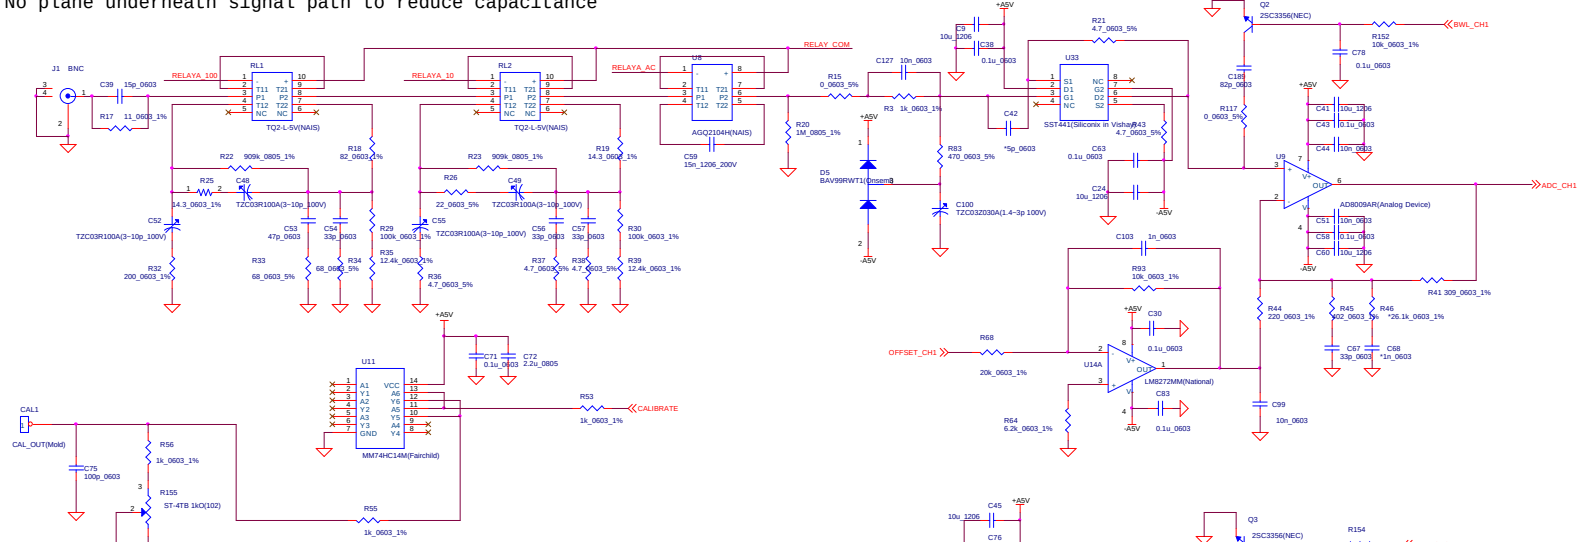
No plane underneath signal path to reduce capacitance

No plane underneath signal path to reduce capacitance
